04-SF-80-KP 12.6/13.9
 04-0120T1
 0400000027
 \$139,000,000
 20.20.202.837

**San Francisco Bay Bridge - Seismic Safety Project
 Fact Sheet Exceptions to Mandatory Design Standards**

This Fact Sheet documents the YBITS Contract 2 design features that require an exception from mandatory design standards. Please see Attachment A for the YBI #2 Contract Project Location Map (Figure A-1) and Project Vicinity Map (Figure A-2).

FIGURE B-1
 MANDATORY DESIGN EXCEPTIONS
 SFOBB SEISMIC SAFETY PROJECT - YBI-2

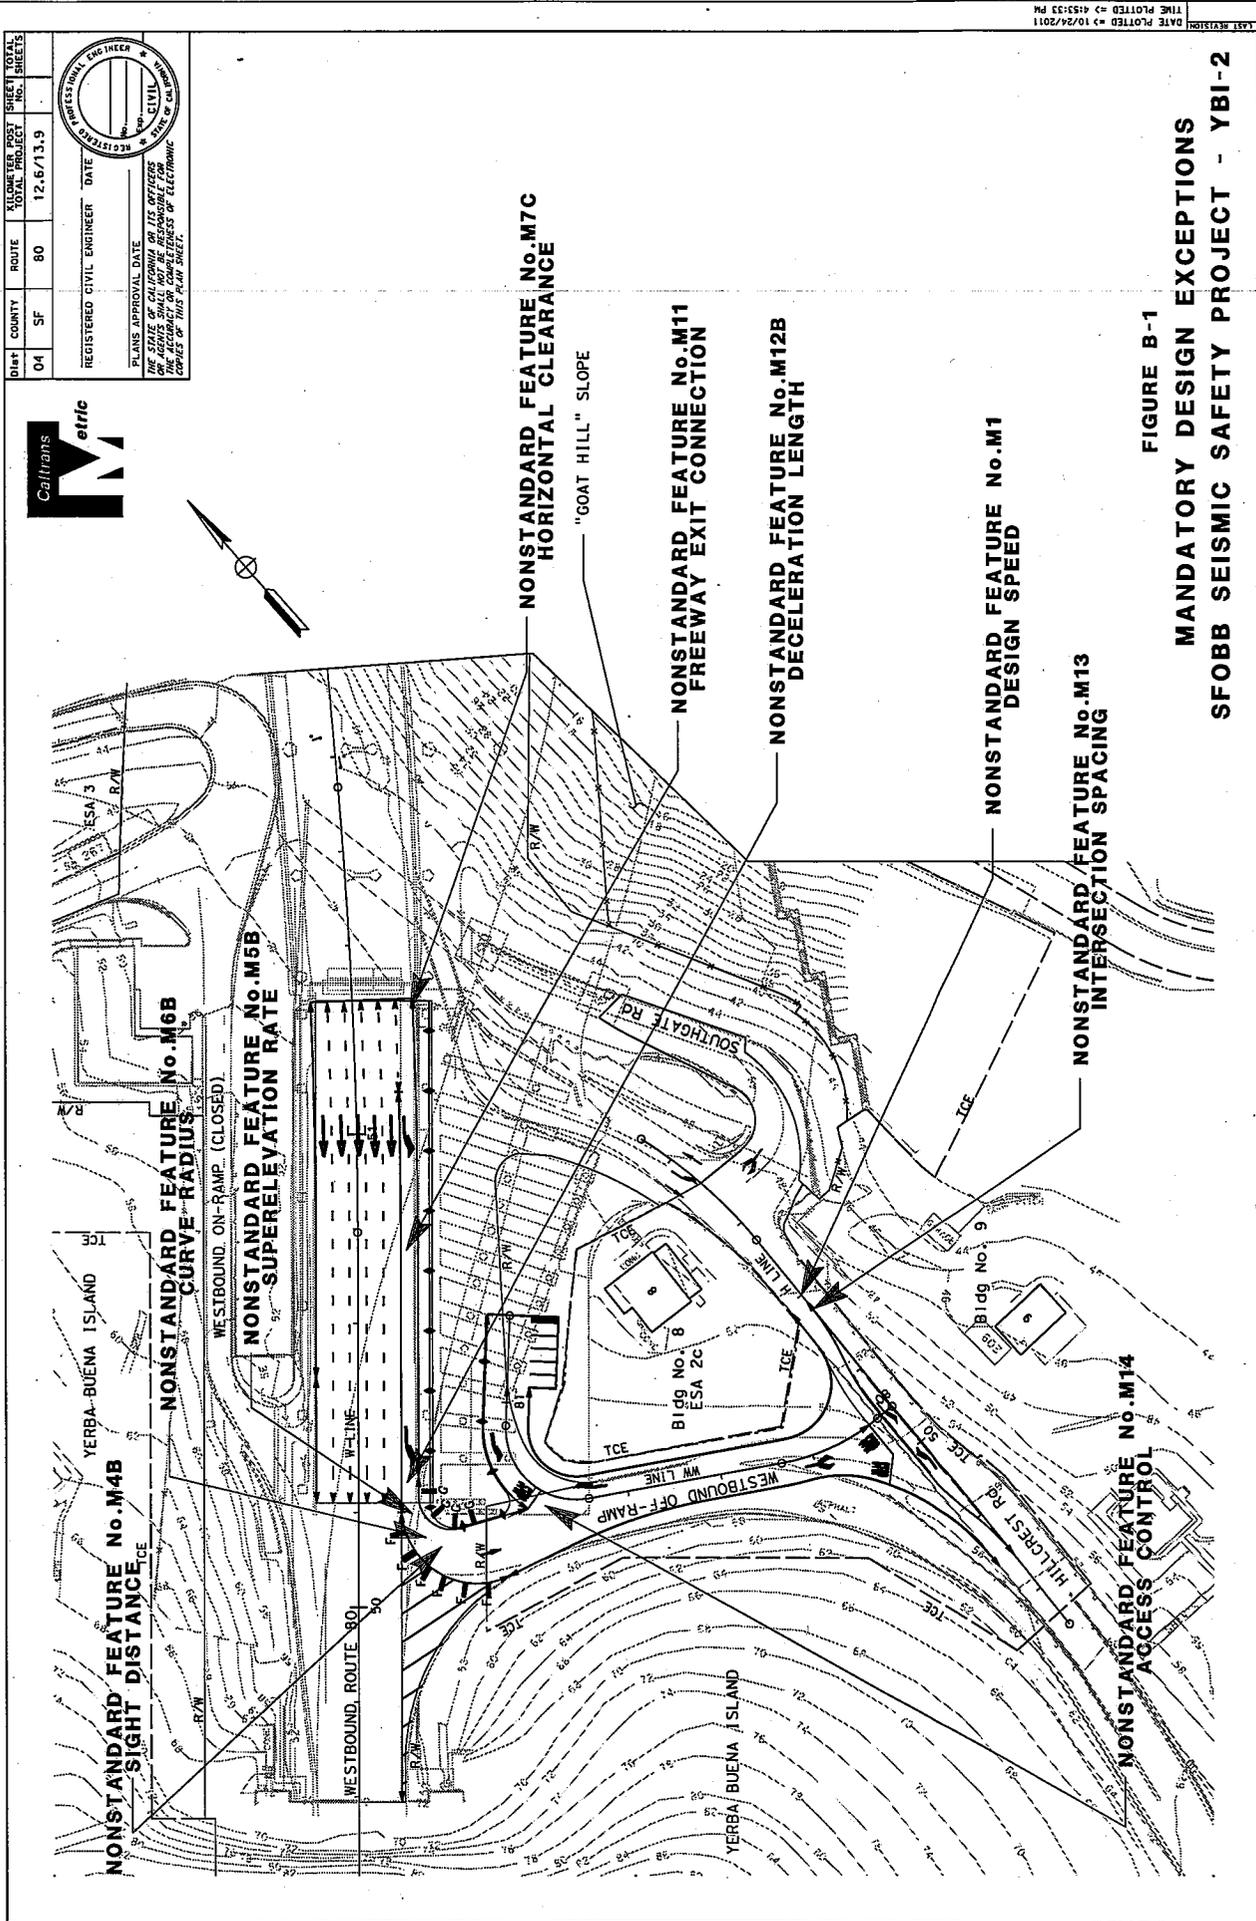
Hillcrest Road, H Line. The proposed design speed is 40 km/h. See Attachment B, Figure B-1.

- (b) WB Off-Ramp, WW Line, First Horizontal Curve. The proposed minimum sight distance at this horizontal curve is approximately 17 m (Design Speed = 17 km/h). See Attachment B, Figure B-1.

- (a) EB Off-Ramp, R4 Line Horizontal Curve (BC 50+94.310/EC 51+35.780). The proposed superelevation rate is 0.075. See Attachment B, Figure B-3.
- (b) WB Off-Ramp, WW Line, First Horizontal Curve. The proposed superelevation rate is 0.01. See Attachment B, Figure B-1.

WB Off-Ramp, WW Line. The proposed exit ramp connects to the left of through traffic on WB I-80. See Attachment B, Figure B-1.

WB Off-Ramp (WW Line) and Southgate Road (SG Line) Intersections with Hillcrest Road. The proposed intersection spacing is 25 m. See Attachment B, Figure B-1.

WB Off-Ramp, WW Line. The parking area for Quarters 8 has access off of the proposed ramp. See Attachment B, Figure B-1.

FIGURE B-3

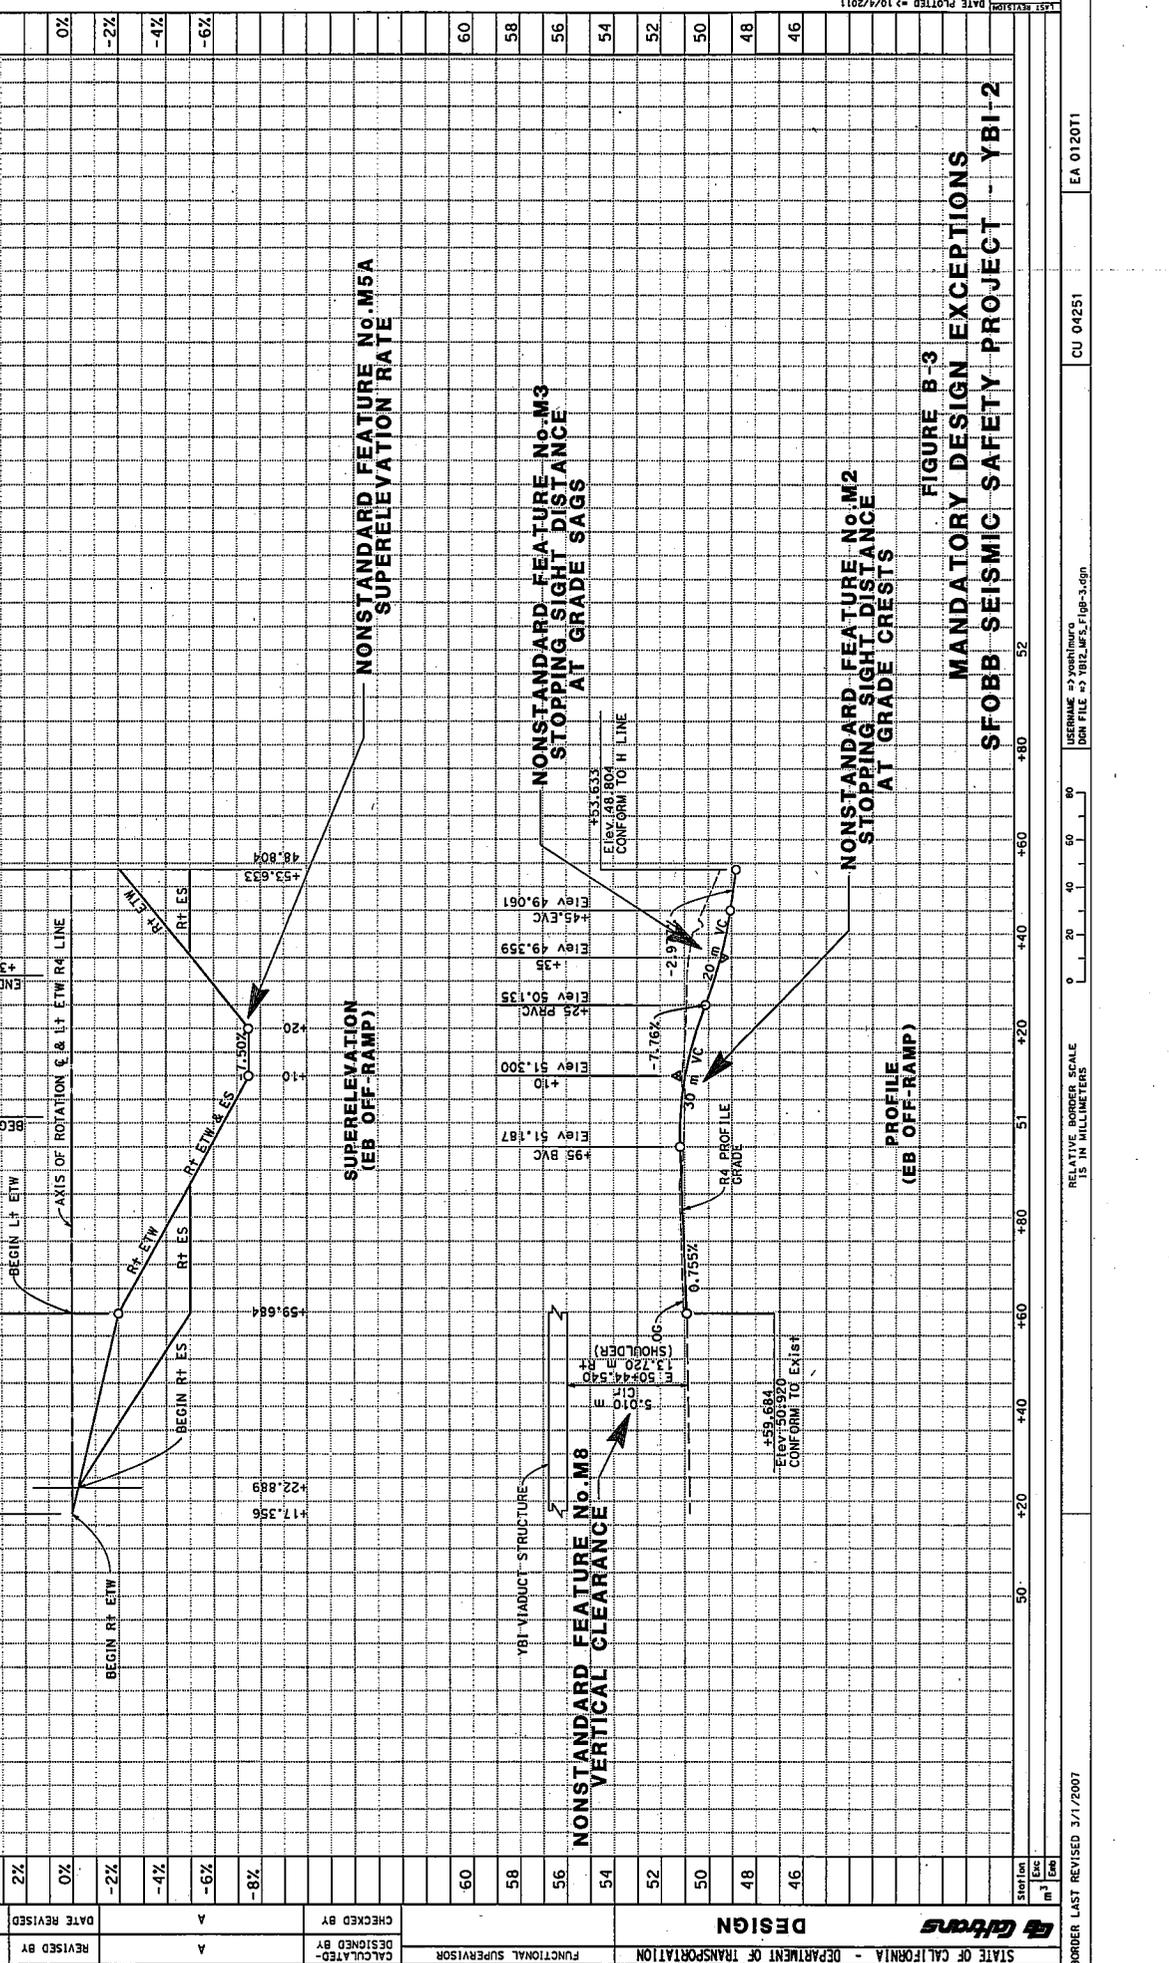
EB Off-Ramp, R4 Line Vertical Curve (BC 50+95.000/EC 51+25.000). The proposed minimum sight distance at this crest vertical curve is 38.82 m (Design Speed = 34.41 km/h). See Attachment B, Figure B-3.

EB Off-Ramp, R4 Line Vertical Curve (BC 51+25.000/EC 51+45.000). The proposed minimum sight distance at this sag vertical curve is 35.51 m (Design Speed = 32.76 km/h). See Attachment B, Figure B-3.

EB Off-Ramp R4 Line. The proposed minimum vertical clearance is 5.01 m. See Attachment B, Figure B-3.

FIGURE B-4
 MANDATORY DESIGN EXCEPTIONS
 SFOBB SEISMIC SAFETY PROJECT - YBI-2

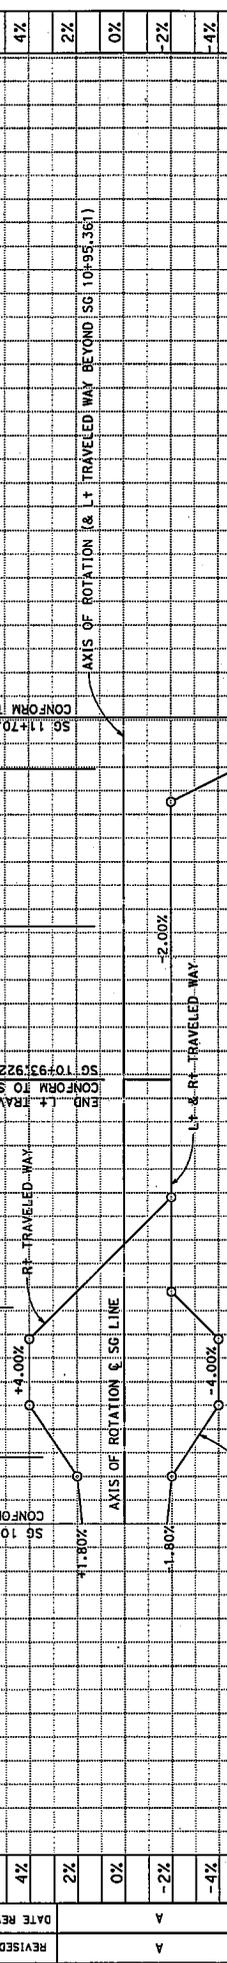
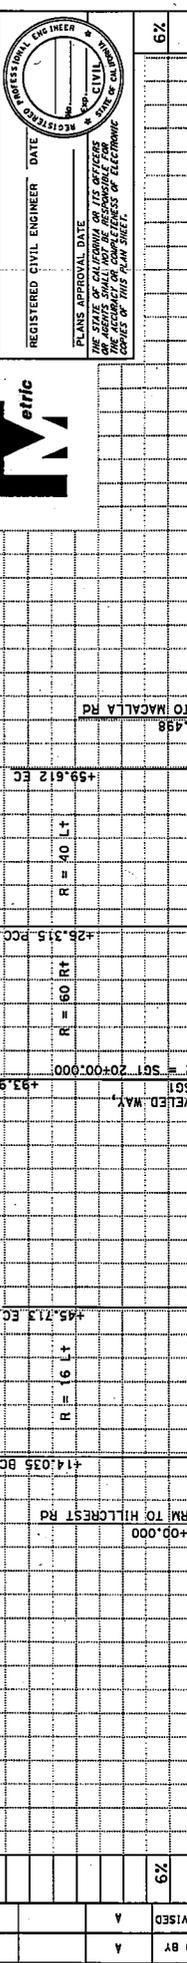
- (a) Southgate Road, SG Line Sta 10+65.000 to Sta 11+05.000. The proposed rate of vertical curvature (K) is 3.03 m/%. See Attachment B, Figure B-4.

FIGURE B-6

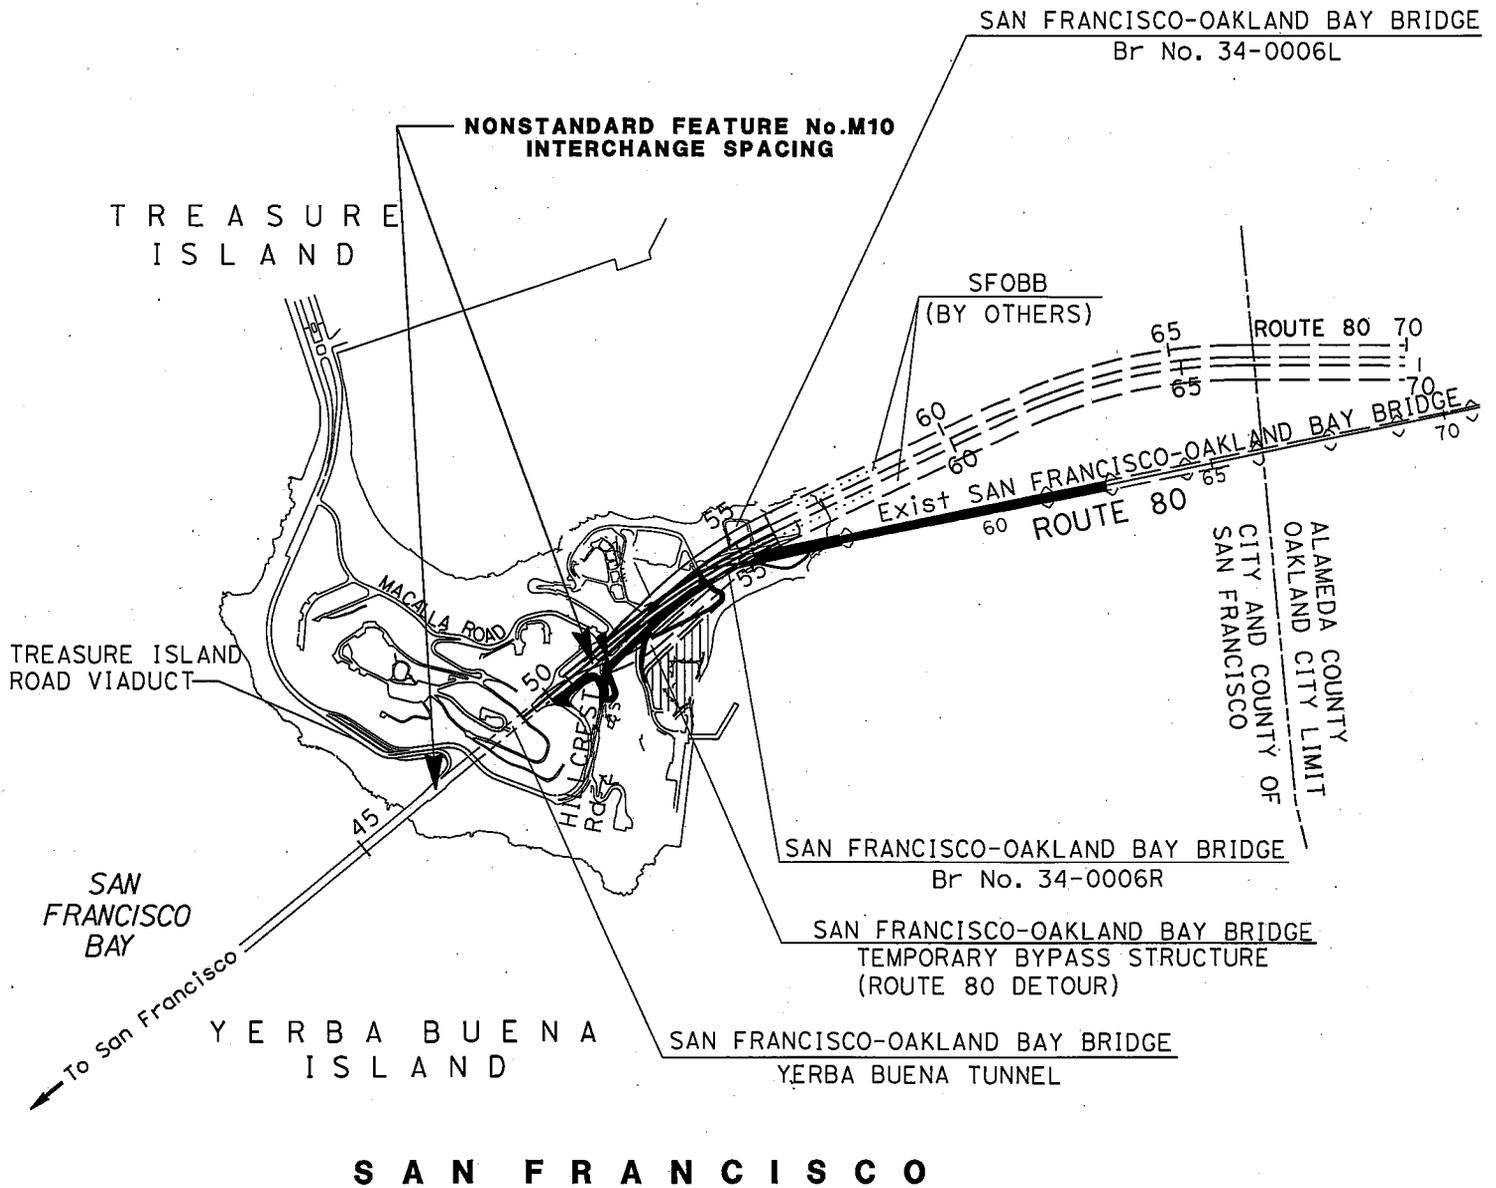
Yerba Buena Island I-80 Interchanges. The proposed interchange spacing is 0.3 km. See Attachment B, Figure B-6.
